OIL - OIL PRESSURE SWITCH RELOCATION

To reduce cyclic loading forces on the Hobbs Oil Pressure Switch.

SEB-79-10  
Page 1 of 2

Figure 1. Oil Pressure Switch Locations (Sheet 1)

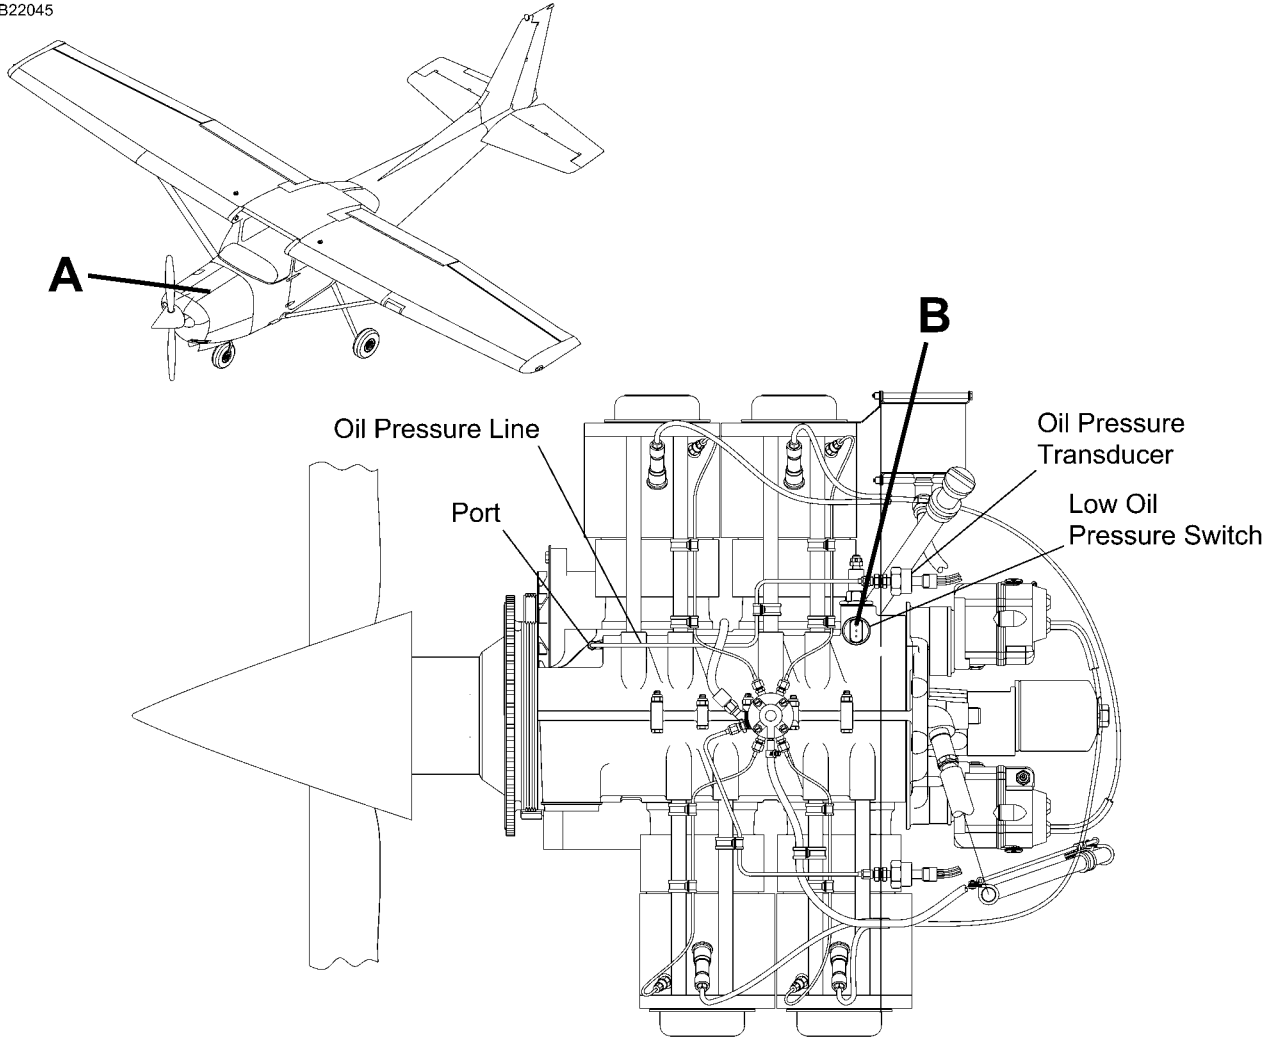
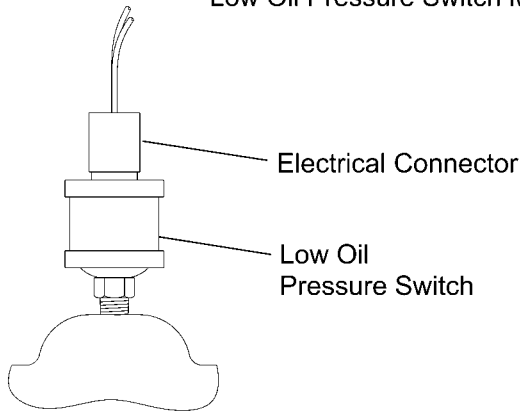
2. Remove the upper cowl. (Refer to the Model 172R/172S Maintenance Manual, Chapter 71, Cowling - Maintenance Practices).
3. (Refer to Figure 1, Sheet 1.) Disconnect the electrical connector (JN005) from the 83278 Oil Pressure Switch (SN001).

4. (Refer to Figure 1, Sheet 1.) Remove and discard the 83278 Oil Pressure Switch mounted on top of the Right-Hand crank case at the aft end.
5. (Refer to Figure 1, Sheet 3.) Remove and keep the 1102 plug from accessory housing oil port.

6. (Refer to Figure 1, Sheet 1.) Put a light coat of U544006 (or equivalent) Sealant on the external (male) threads of the 1102 Plug and install in the right side engine crankcase engine oil port and torque 40 to 44 Inch-Pounds. Do not allow sealant to enter oil port.
7. (Refer to Figure 1, Sheet 2.) Install the 83278 Oil Pressure Switch as follows:

Figure 1. Oil Pressure Switch Locations (Sheet 2)

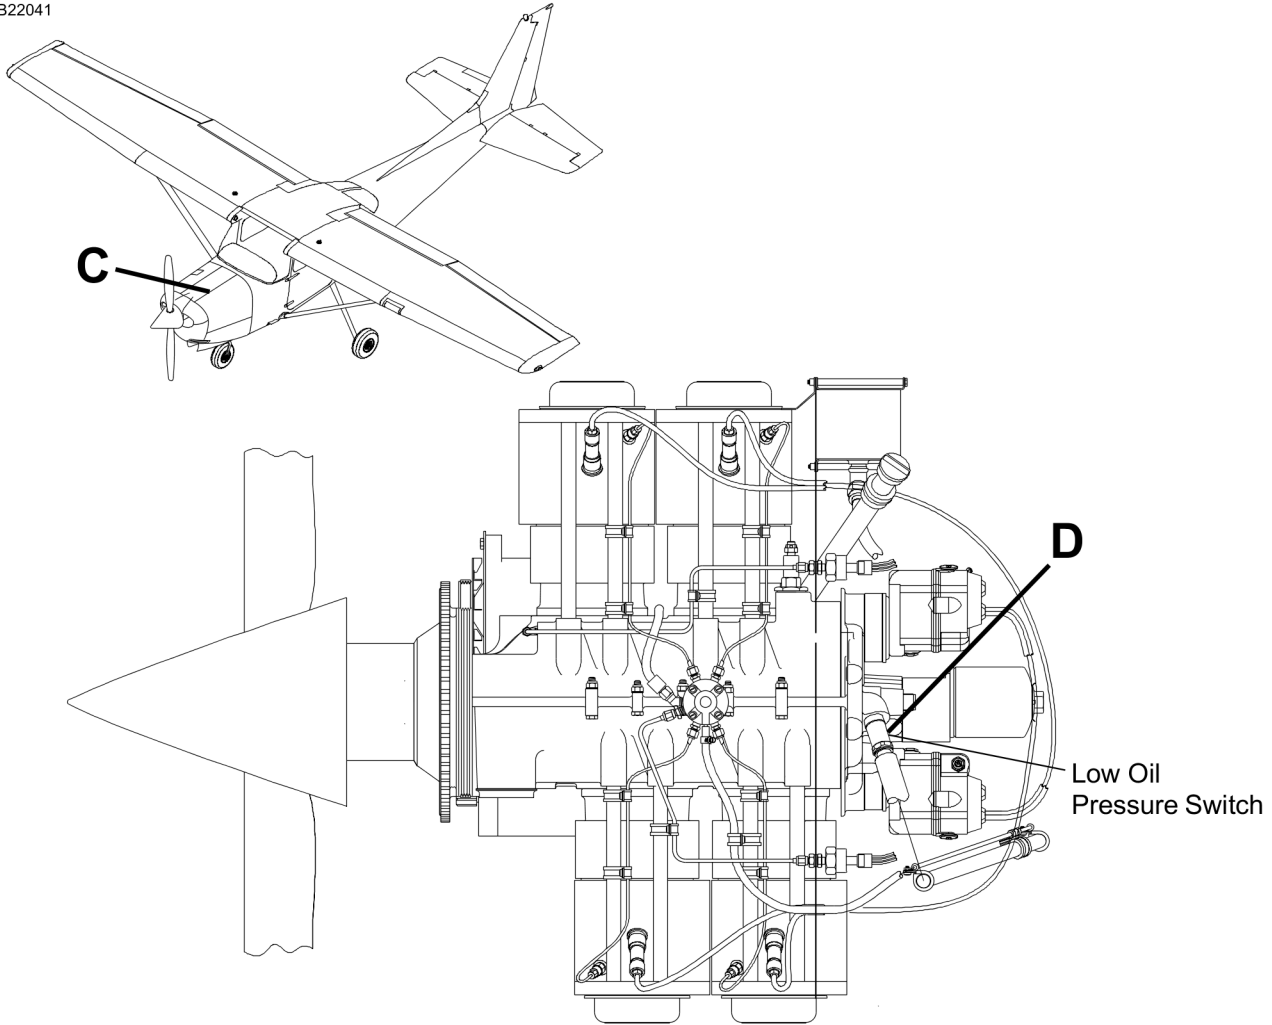
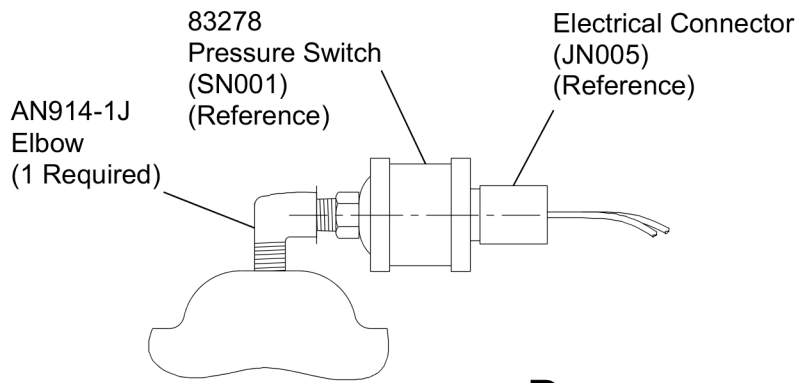
- A. Put a light coat of U544006 (or equivalent) Sealant, on the external (male) threads of the AN914-1J Elbow and 83278 Oil Pressure Switch.
- B. Install the AN914-1J Elbow until hand tight then rotate one additional turn and then rotate until the elbow is in an aft direction that provides clearance as not to be in contact with any other components.
- C. Install the new 83278 Oil Pressure Switch to the AN914-1J Elbow.
  - (1) Make sure that there is optimum clearance of all surrounding components and structure.

**CAUTION:** Use only the hex fitting to final tighten. Do not use plier-type tools on the plastic housing or the circular metal base of the 83278 Oil Pressure Switch. The switch can be damaged between the swaged connections between plastic housing and circular metal base and/or the metal base and the hex fitting. Damage to either of these swaged connections can cause an oil leak.

- D. Tighten the 83278 Oil Pressure Switch approximately 1 to 1 1/2 turns beyond hand tight.
